UNITED STATES  
DEPARTMENT OF THE INTERIOR  
BUREAU OF LAND MANAGEMENT

**SUNDRY NOTICES AND REPORTS ON WELLS**  
**Do not use this form for proposals to drill or to re-enter an abandoned well. Use Form 3160-3 (APD) for such proposals.**

EOG respectfully requests an amendment to our approved APD for this well to reflect the following changes:

Deep Elem 4 Fed Com 769H (FKA 586H) API #: 30-015-47939

Revised Wellbore

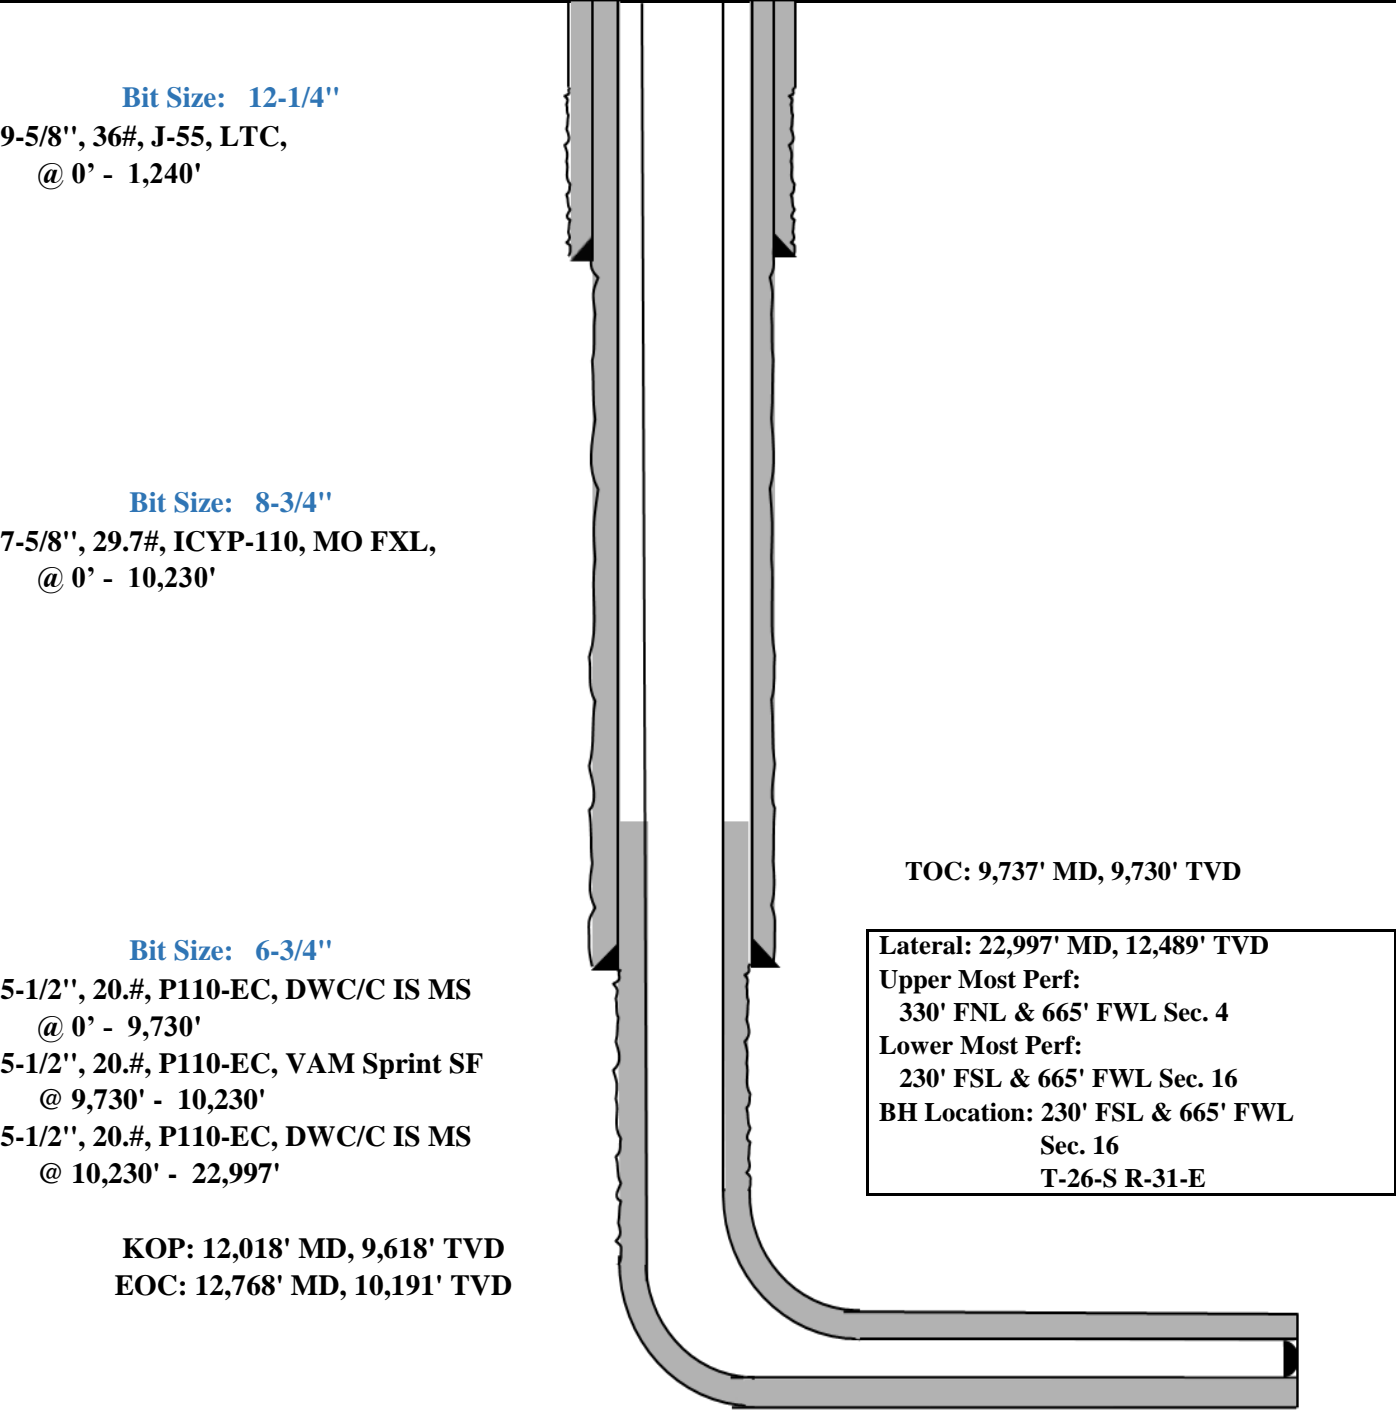
Change name from Deep Elem 4 Fed Com 586H to Deep Elem 4 Fed Com 769H.

Change BHL from T-26-S, R-31-E, Sec 16, 100' FSL, 330' FWL, Eddy Co., NM,  
to T-26-S, R-31-E, Sec 16, 230' FSL, 665' FWL, Eddy Co., N.M.

Change target formation to Wolfcamp M2.

Update casing and cement program to current design. Batch #2777328
